GOVERNMENT OF THE DISTRICT OF COLUMBIA
Zoning Commission

Re: Z.C. Case No. 08-30 - Application for Capitol Gateway Overlay Review by West Half 1 LLC, West Half 2 LLC and West Half 3 LLC

HALF STREET
SQUARE 700

Section A

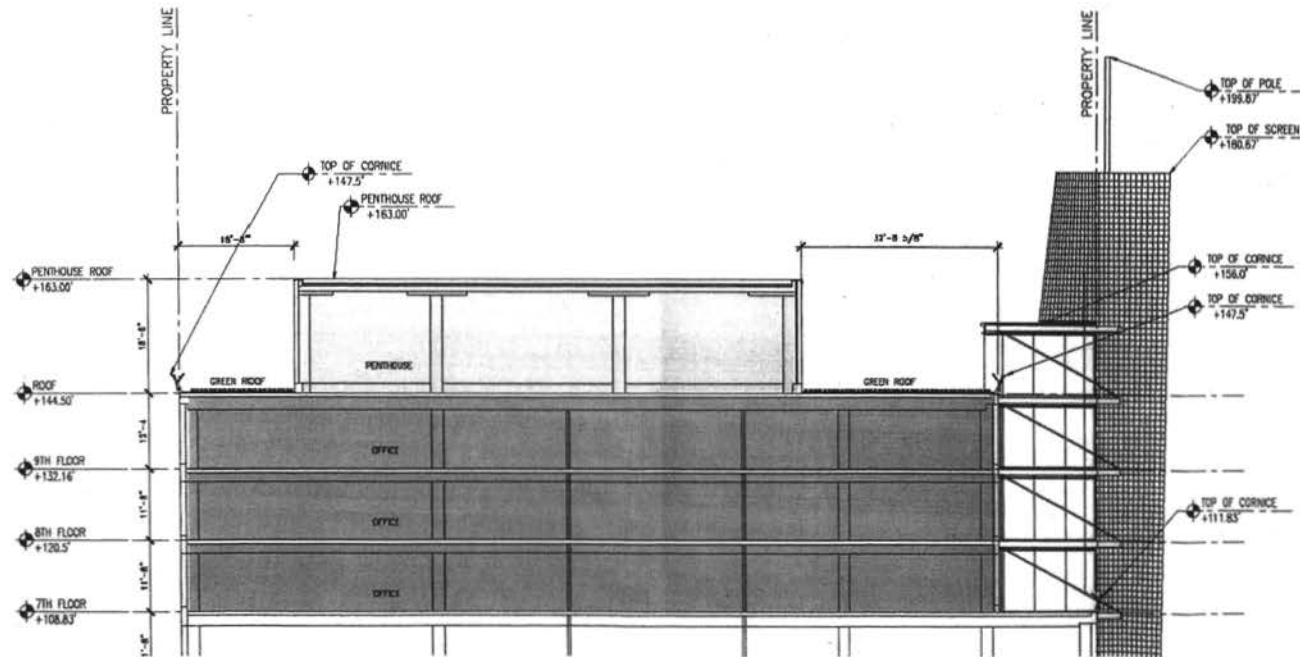
In particular, the Commission is concerned that the roof over the roof terrace shown in the roof level plan exceeds the 110 foot height limit, and does not appear to be one of the enumerated architectural embellishments permitted to exceed the limit by the Height Act if a waiver is granted by the DCRA Director pursuant to 12A DCMR § 105.3.1.8.

The roof is depicted in the drawing entitled "Section A" on page RS2, located behind Tab A of the Applicant's February 9, 2009 submission given Exhibit No. 31, a copy of which is attached

As indicated in its order granting the application, the Commission does not believe the design is a clear cut violation of the Height Act, but instead believes the design may violate the Height Act, depending on how it is interpreted. The Commission requested that I write you to alert you to the Height Act issue so that you can consider it when you review the Applicant's request for a building permit. The Commission also requested that you report your conclusion back to the Commission so that it can benefit from your interpretation in reviewing future cases.

21 COMMISSIONER MAY: And you see
22 there the roof line is at 144 1/2.

2 COMMISSIONER MAY: And then above
3 that, you have the tower roof at 157.67.

6 COMMISSIONER MAY: It's not set
7 back at all from the edge of the building.

8 Essentially, my question here is
9 that you can exceed 110 feet with an
10 architectural embellishment. The question is
11 whether we consider the roof over the roof
12 deck to be an embellishment or not. And I'm
13 not sure that I agree with that opinion. But
14 I'm interested in hearing what the rest of the
15 Commission has to say.
